MONTGOMERY COUNTY HISTORIC PRESERVATION COMMISSION
STAFF REPORT

Address:	7324 Baltimore Avenue, Takoma Park	Meeting Date:	10/25/2023
Resource:	Contributing Resource Takoma Park Historic District	Report Date:	10/18/2023
Applicant:	Conor McCarthy (Richard J. Vitullo, Architect)	Public Notice:	10/11/2023
Review:	HAWP	Tax Credit:	Partial
		Staff:	John Liebertz

PROPOSAL: For demolition of rear addition, construction of new addition, and fenestration alterations.

Figure 2: View of the 1927 Sanborn Fire Insurance Map (left). View of the façade, 1988 (upper middle) and 2023 (lower middle). View of the rear elevation, 1988 (upper right) and ca. 2022 (lower right). Source: Sanborn Fire Insurance Company, Applicant, Montgomery Planning.

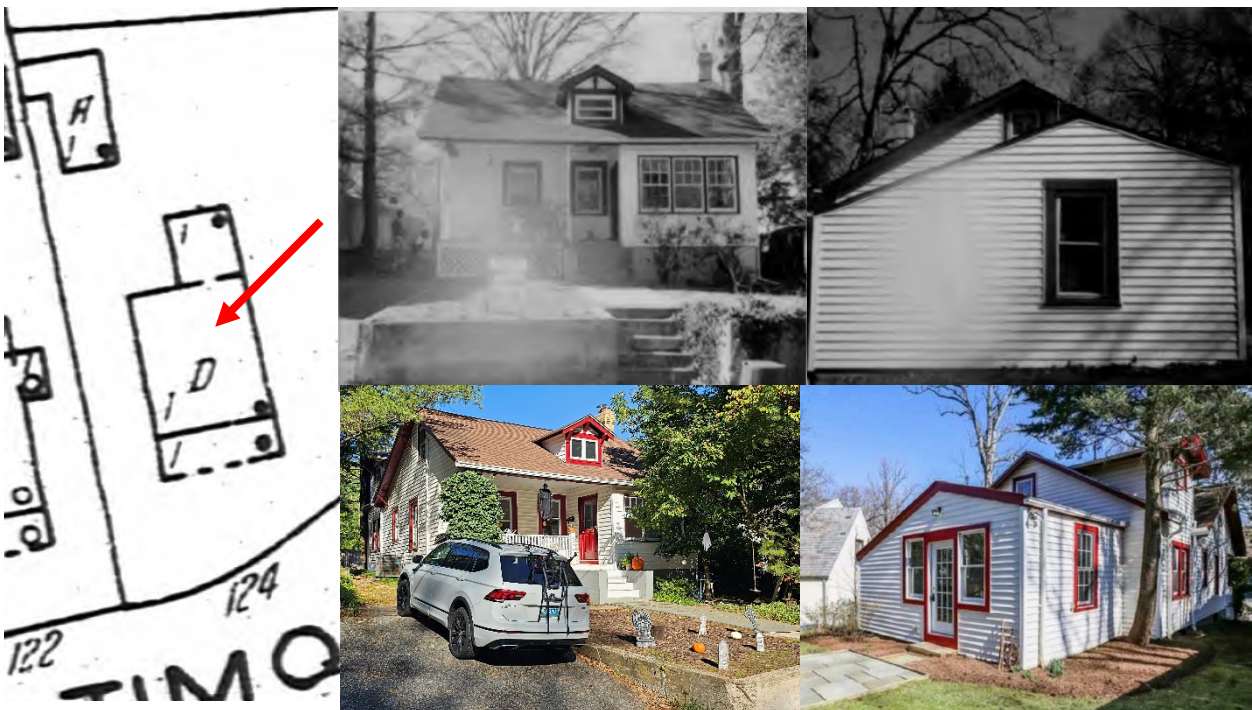
The subject property located near the intersection of Baltimore Avenue and Albany Avenue is a Contributing Resource to the Takoma Park Historic District. The site features a Craftsman-styled, wood-frame house constructed ca. 1921. The one-and-a-half-story, three-bay, side-gable house with a gable dormer (*Figure 2*) rests on a concrete foundation. The original wood lap siding is covered with vinyl siding that was installed in the last quarter of the twentieth century. The façade features a recessed, partially infilled porch accessed by a centrally located stair. In the last quarter of the twentieth century, the property owners constructed a one-story, wood-frame, gable roof, rear addition. The addition rests on a concrete block foundation and is clad with vinyl siding.

In 1988, the Historic Preservation Commission approved various alterations to the house including: 1) the installation of the brick pier and tapered wood post on the front porch; 2) the replacement of non-historic window in the front dormer; 3) the construction of a side dormer on the southern roof slope; and 4) the

new fenestration to the non-historic rear addition.¹ Fenestration on the addition consists of six-over-six, six-over-one, and one-over-one windows and multi-light, single-leaf doors. Recently, the rear addition was damaged beyond repair during a storm when a tree fell.

Figure 3: View of the first-floor plan showing the location (red arrows) of the eight vinyl-sash windows to be replaced.

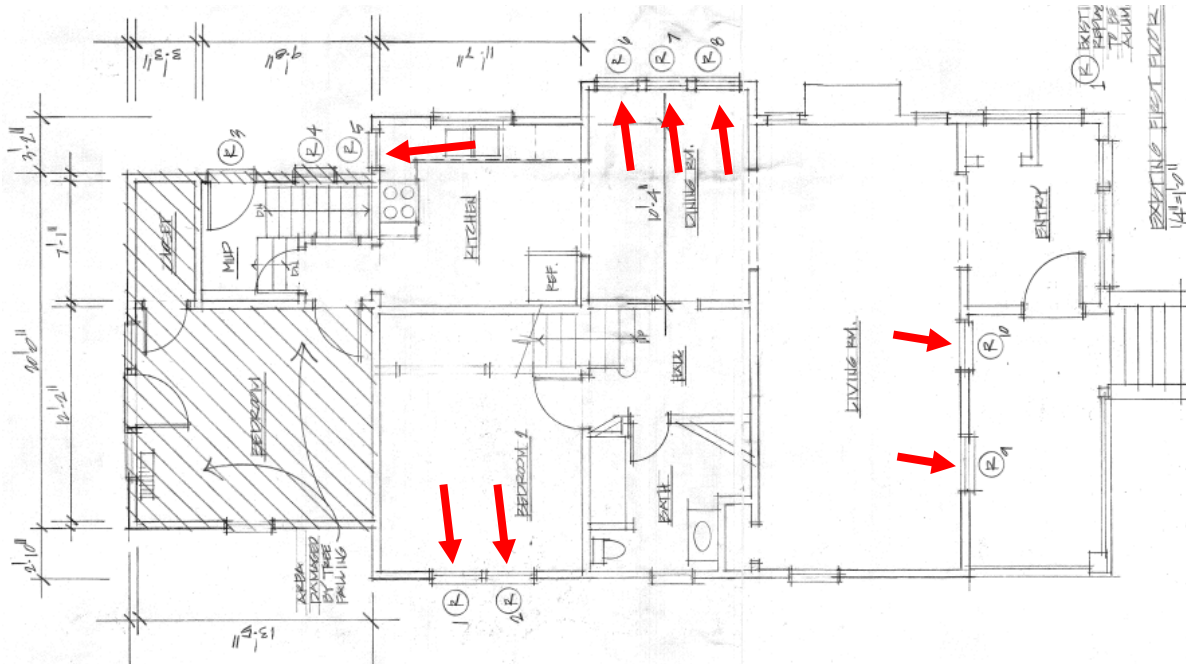
Staff finds the proposed replacement of the eight (8) vinyl windows on the first story with simulated divided light, aluminum-clad, wood windows to be consistent with the applicable guidelines and recommends approval (*Figure 3*). The proposed design is compatible with the Craftsman-style of the house. There are no historic photographs available that depict the original design of the windows. The replacement of vinyl-sash with aluminum-clad, wood windows is an appropriate substitution in this case.

Figure 4: View of the rear upper gable end window (red circle) to be replaced.

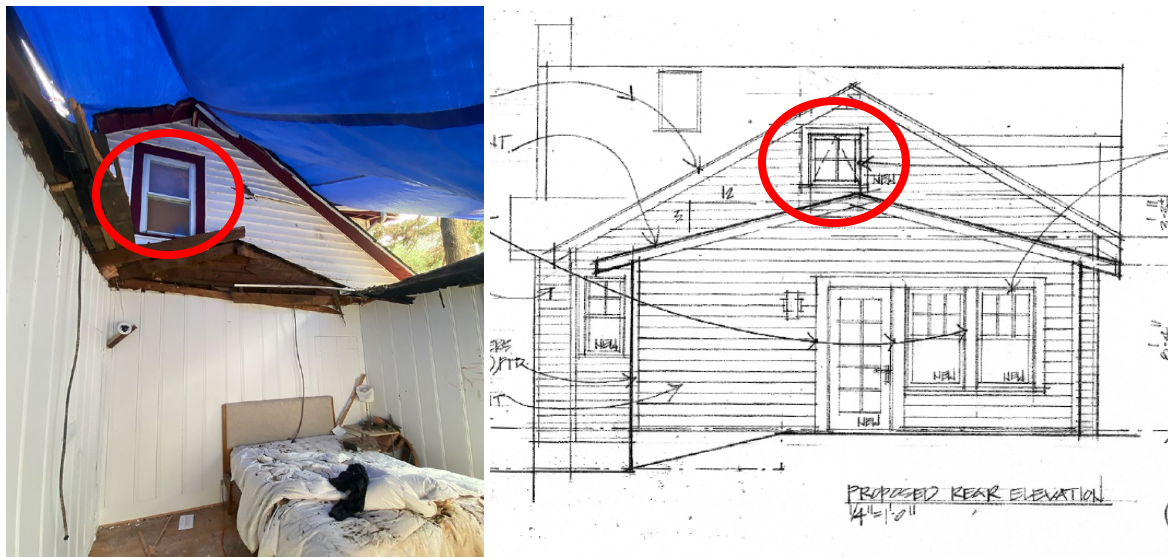
Staff finds the alteration to the size of the window opening and replacement of the one-over-one, double-hung, vinyl-sash window with a smaller four-light, aluminum-clad, wood, awning window to be consistent with the applicable guidelines and recommends approval (*Figure 4*). The proposed window located in the upper gable end of the rear elevation would permit for the construction of the addition. Salvaged vinyl siding would be utilized to infill any missing sections. This alteration would not be visible from the public rights-of-way and should be approved as a matter of course.
